**FINAL DECISION AND RESPONSE TO COMMENTS
ON THE EXPLANATION OF SIGNIFICANT DIFFERENCES**

**FORMER AMETEK U.S. GAUGE DIVISION – PLANT #2
SELLERSVILLE, PENNSYLVANIA
EPA ID#: PAD002342236**

**FINAL DECISION AND RESPONSE TO COMMENTS
ON SELECTION OF CORRECTIVE MEASURES UNDER SECTION 3008 (h) OF THE
RESOURCE CONSERVATION RECOVERY ACT**

**AMETEK U.S. GAUGE DIVISION – PLANT #2
SELLERSVILLE, PENNSYLVANIA**

FIGURE 2

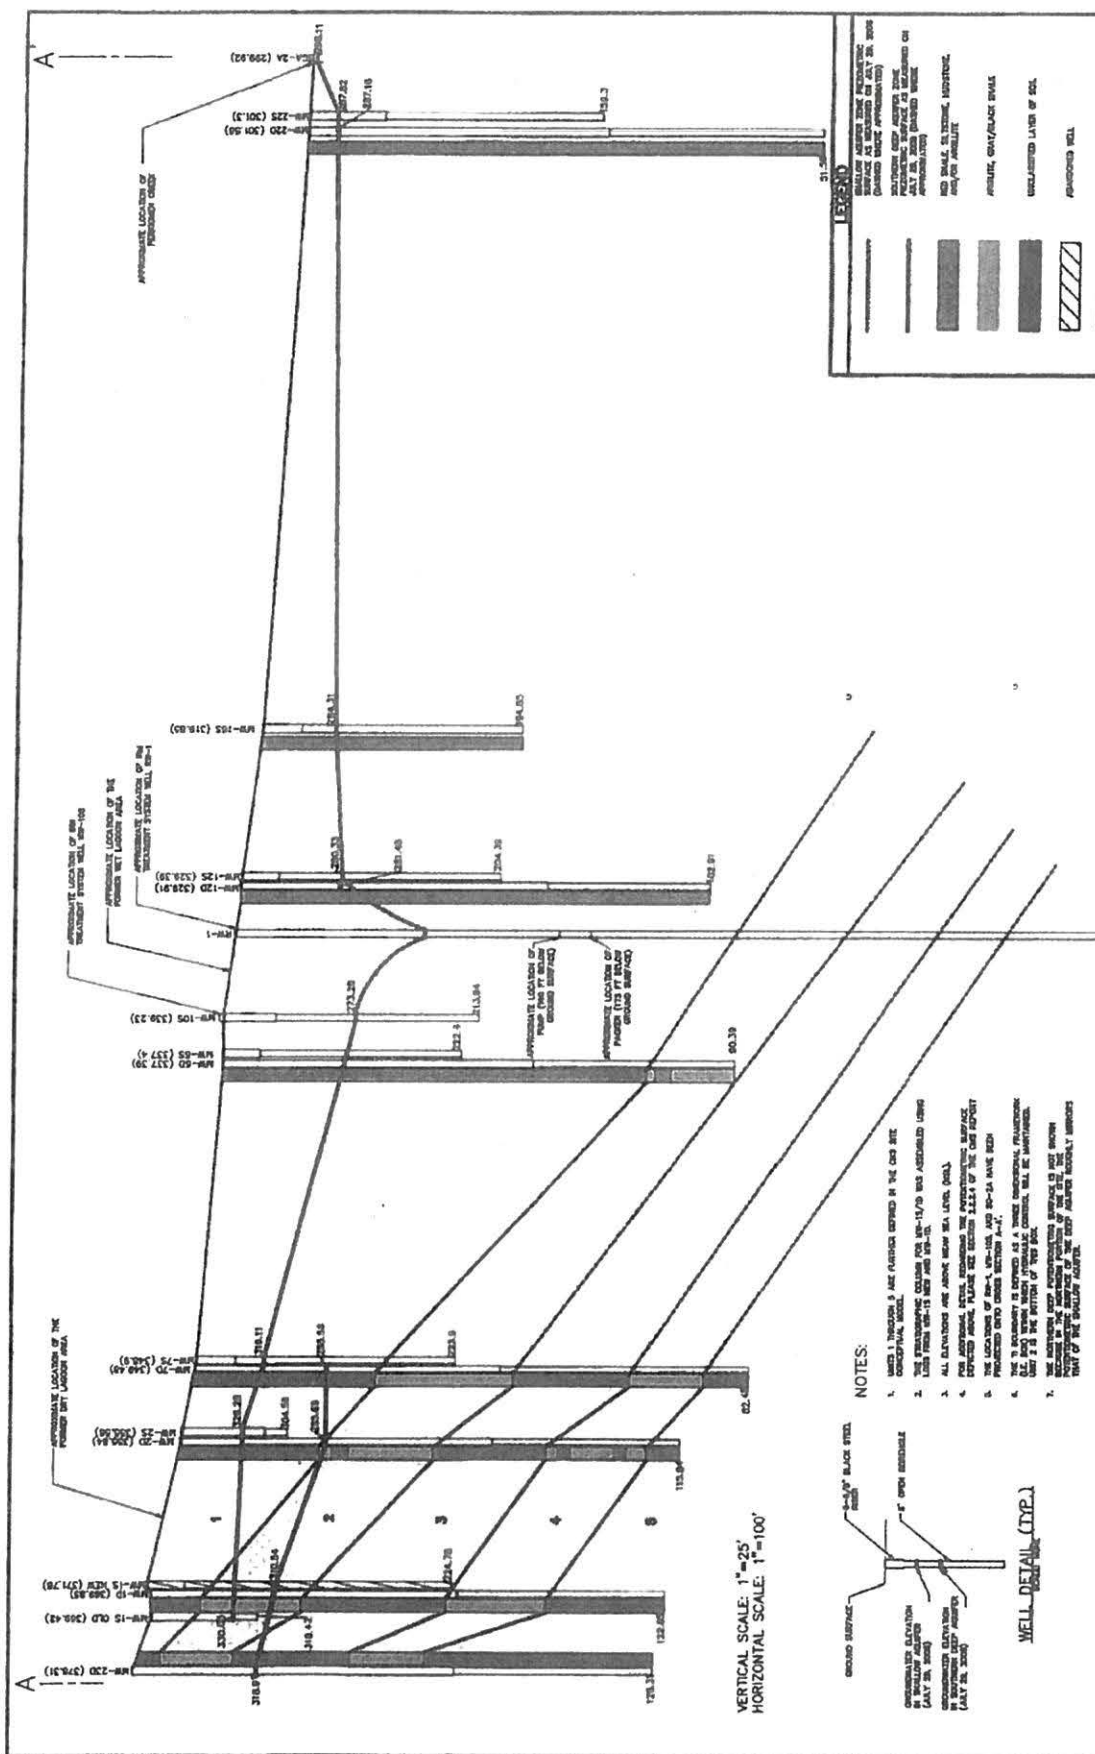
15. Comment: Clarification is needed regarding why the B-B cross-section, as referenced in various Malcom Pirnie reporting, was omitted from the Statement of Basis. This cross-section represents the COC path of the most contaminated portion of Ametek's property

EPA Response: The purpose of the SB document is to summarize the investigation and to present the proposed remedy. The attached A-A cross-section to the SB document presents key features that pertain to the proposed remedy such as the contamination source areas (Former Wet Lagoon and Former Dry Lagoon Areas) where the highest levels of TCE are detected and the location of active groundwater extraction and treatment system recovery wells.

MALCOLM PIRNIE, INC.
FIGURE 1

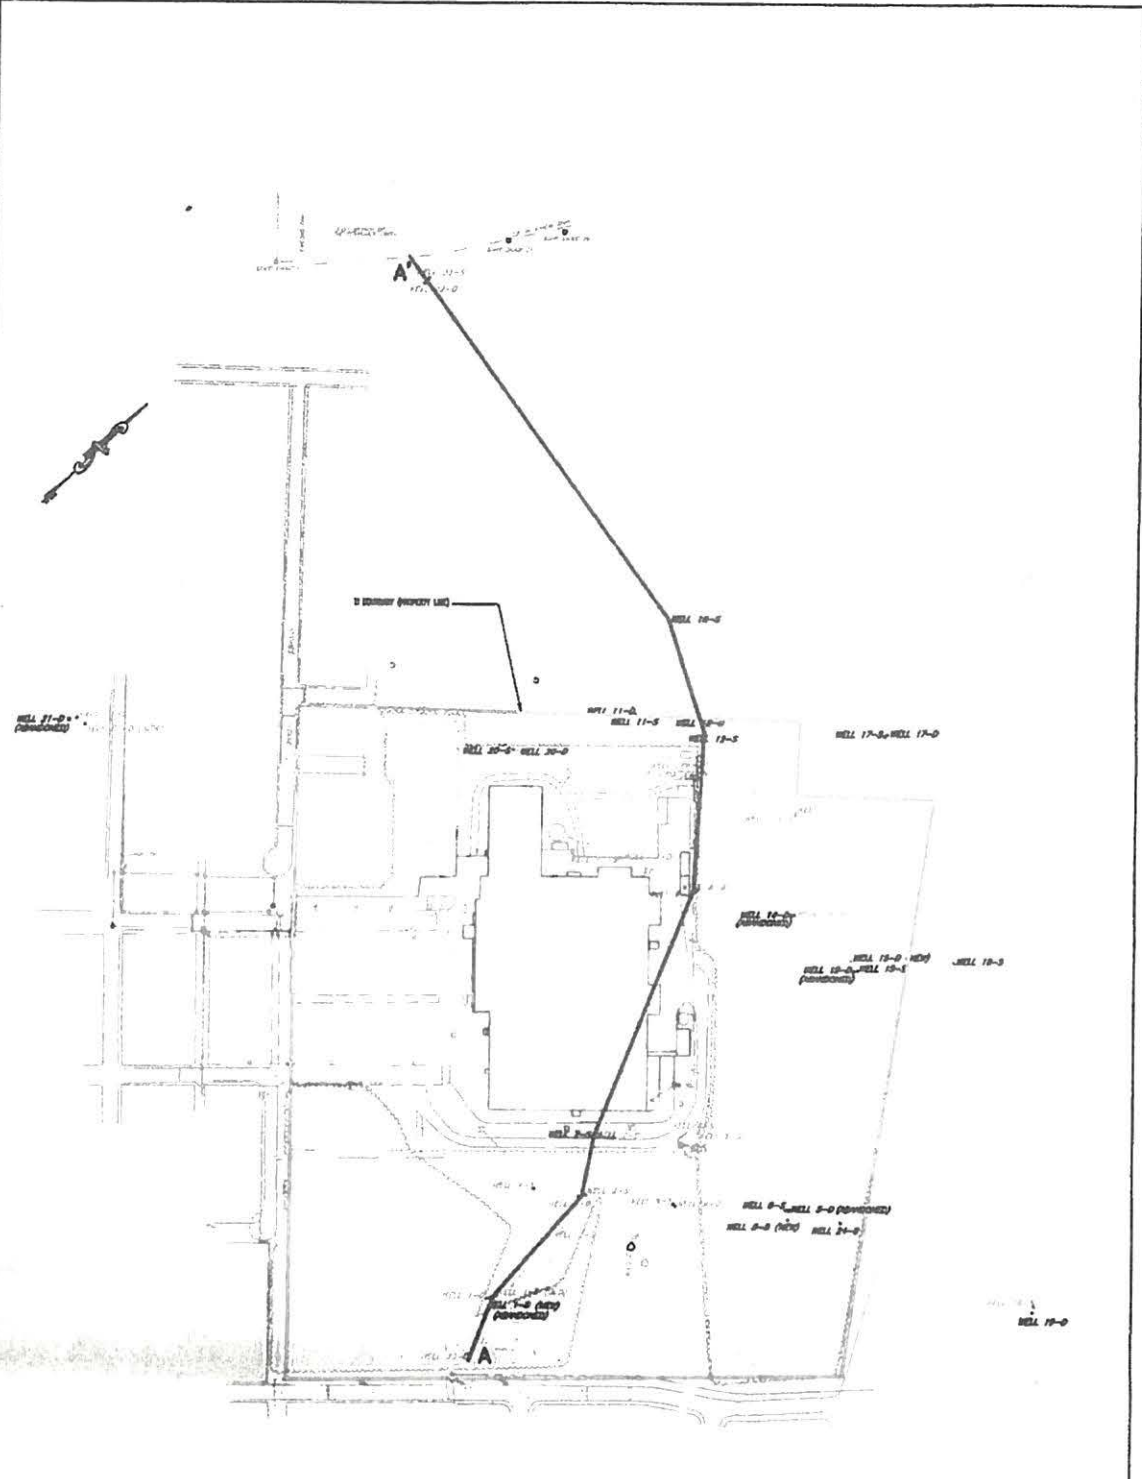
8. Comment: Clarification is needed regarding exactly what specific area is covered within the "TI" boundary.

work to ensure that the high-level/untreatable contamination remains within/does not extend beyond this zone [i.e. remains underneath the homes in question]. The only wells in Figure 1 on page 18 of the Statement of Basis that are NOT included in this zone are 21D, 21S, 22D, and 22S. All other wells noted in blue--both inside AND outside Ametek's property line--are a part of this zone, and it is within this zone that contamination levels will remain above legal and health limits. Based upon Malcom Pirnie reporting, the establishment of "Technical Impracticability" for this zone means that toxic levels will stay above legal MCL limits here, but the pump-and-treat/monitoring well system will ensure that contamination does not spread BEYOND here. In light of the info relayed in comment #13, clarification is needed regarding the future deed restrictions reflecting permanent land use prohibitions for all residences located within this "TI Zone," and how they--coupled with myriad health-related concerns--will have tremendous impact on residents, property values, and the homeowners' ability to resell their homes. Those who live in the affected areas need to be advised that 1) their property is permanently impaired, 2) they have been living on top of carcinogenic toxins unknowingly for decades, and 3) their health, homes, and financial security have been/will negatively [sic] affected as a result.

EPA Response: The designated TI boundary is the Ametek Plant #2 property boundary, which is shown graphically in Figure 1 of the Statement of Basis.

EPA Response: Please see EPA response to comments #13, 16, 17 and 18. The TI Zone consists of only the Ametek Plant #2 property. No other properties are located within the TI Zone.
